# CITY OF ALBUQUERQUE

May 29, 2015

**Re: Starbucks**  
**4407 Lomas Blvd, NE**  
**Traffic Circulation Layout**  
Engineer's/Architect's Stamp dated 5-29-15 (J17-D012)

SITE PLAN FOR BUILDING PERMIT

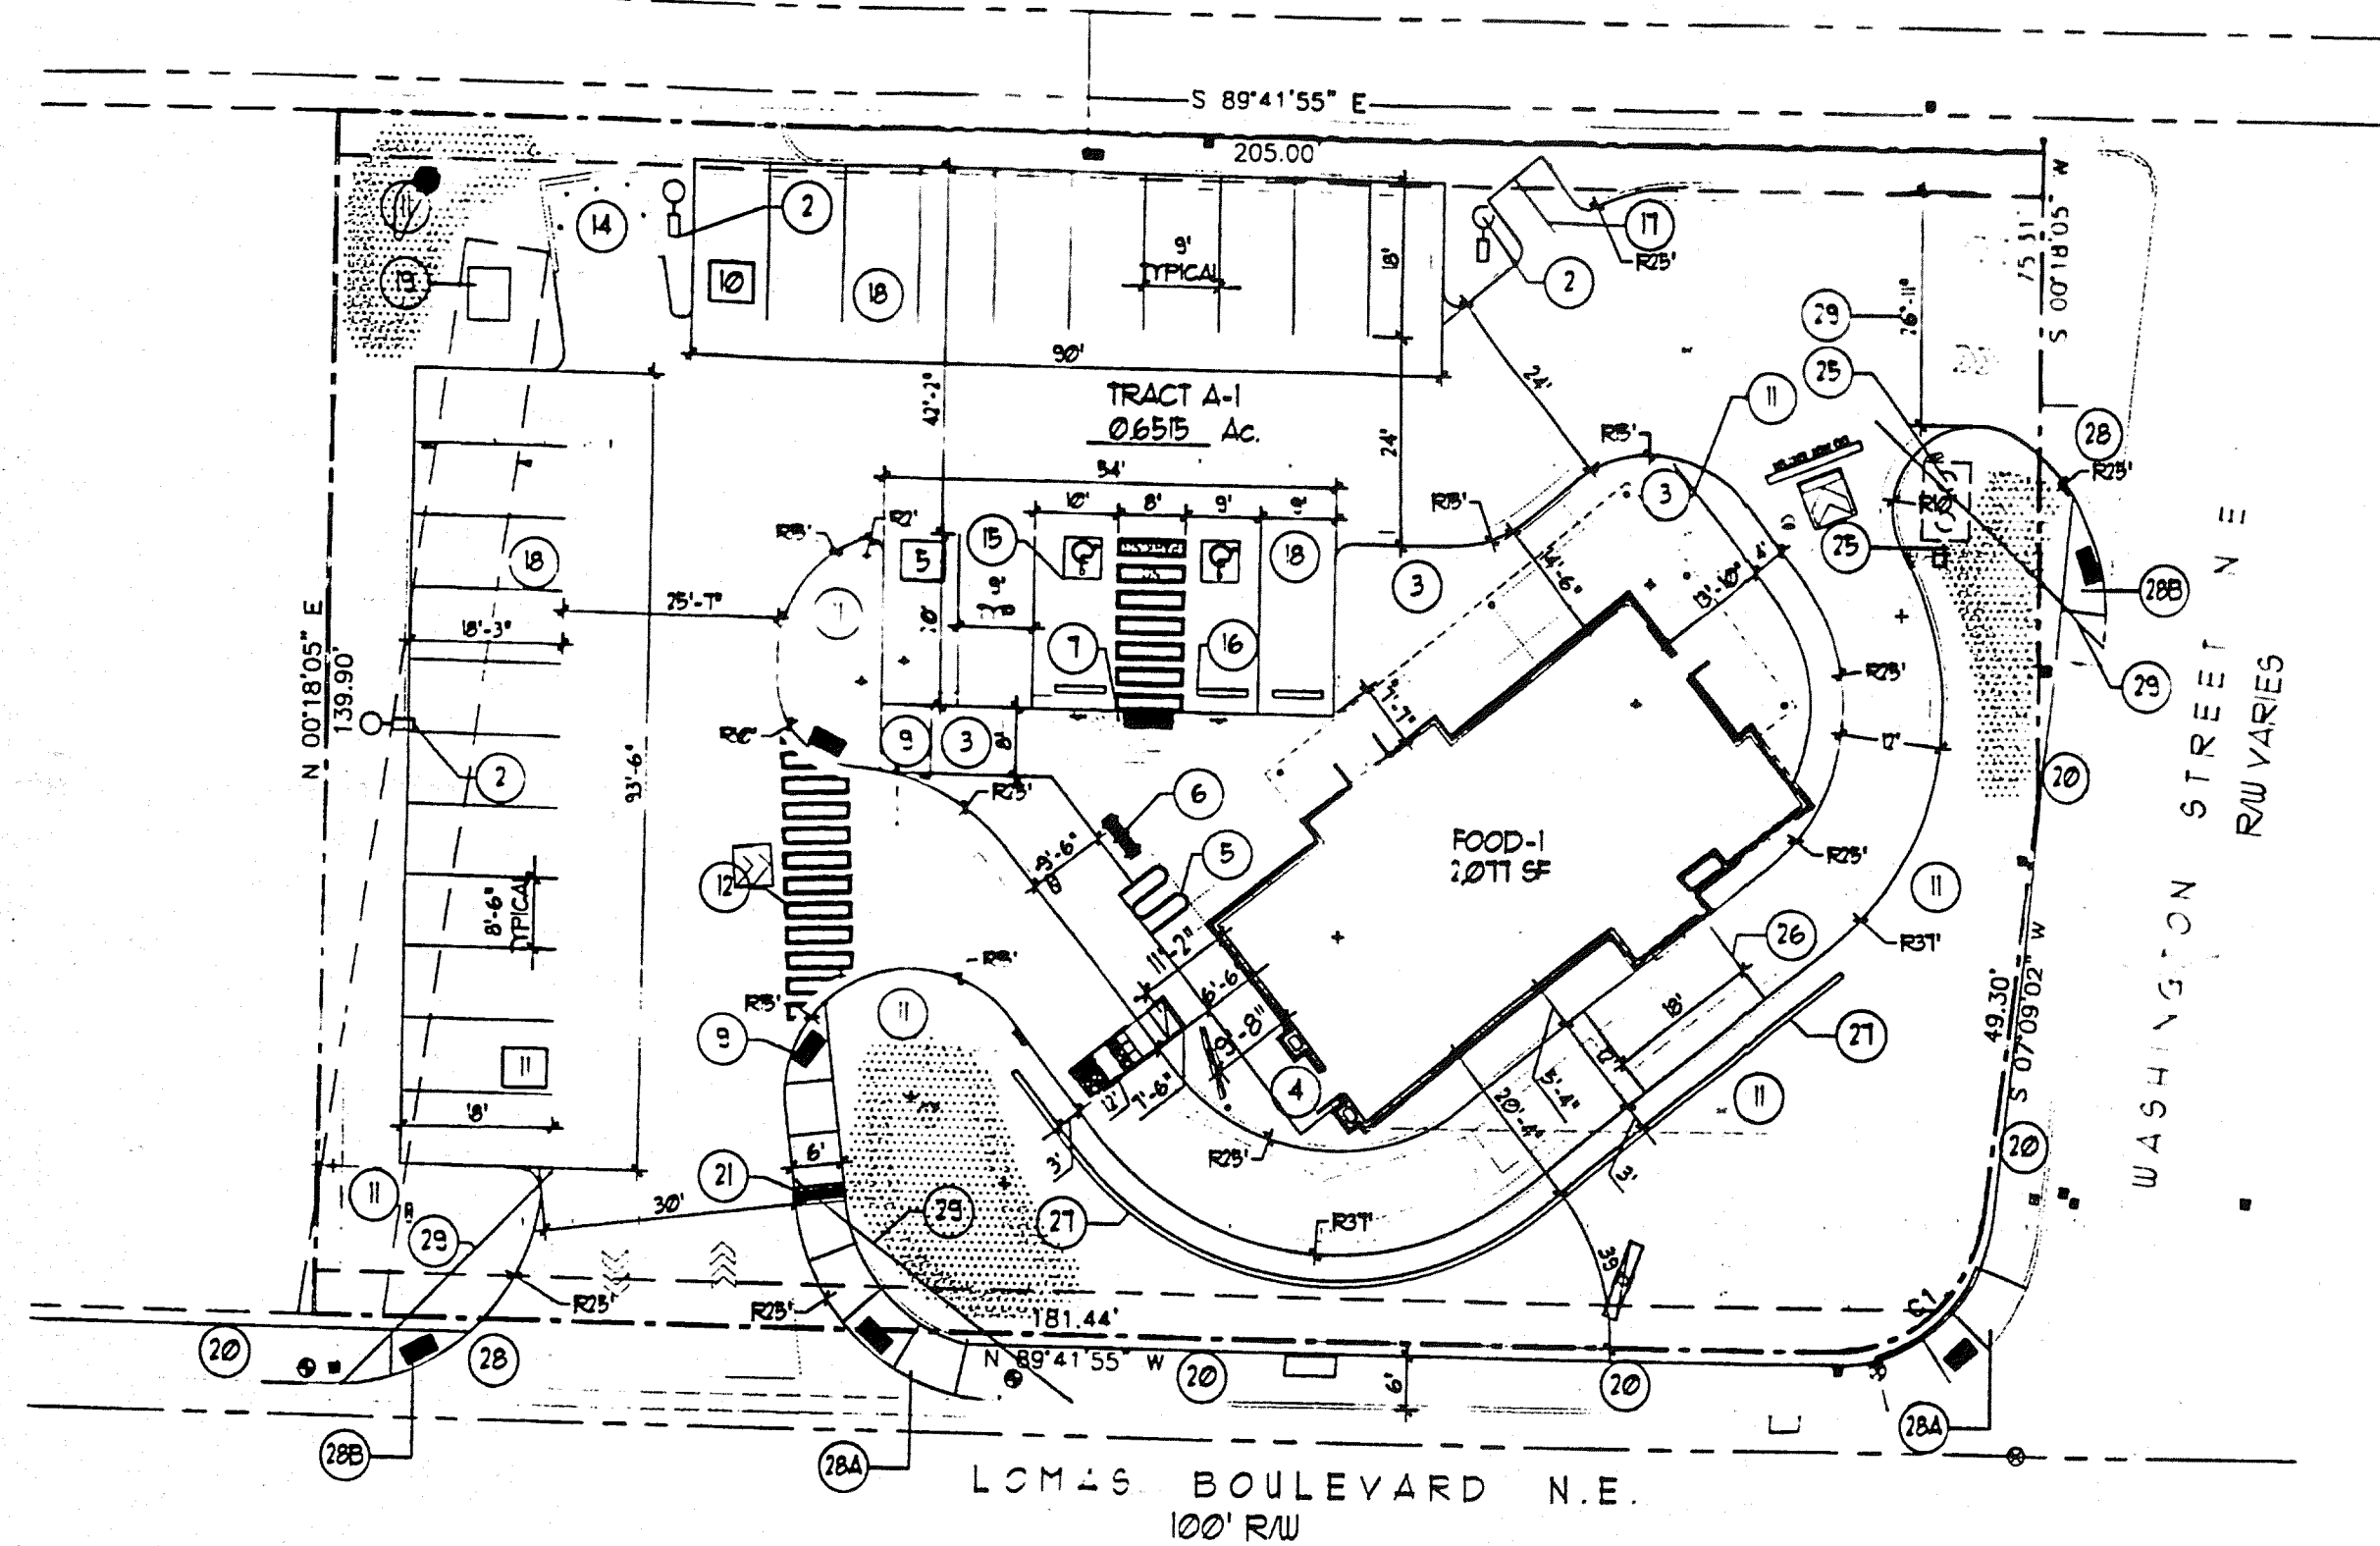
The TCL submittal received 5-29-15 is approved for Building Permit. A copy of the stamped and signed plan will be needed for each of the building permit plans. Please keep the original to be used for certification of the site for final C.O. for Transportation.

TRAFFIC CIRCULATION LAYOUT APPROVED

Public Infrastructure shown on these plans for information only and not part of approval. Separate DRC/Permit approval and Work Order required.

ALL WHEELCHAIR RAMPS LOCATED WITHIN THE PUBLIC RIGHT OF WAY MUST HAVE TRUNCATED DOMES.
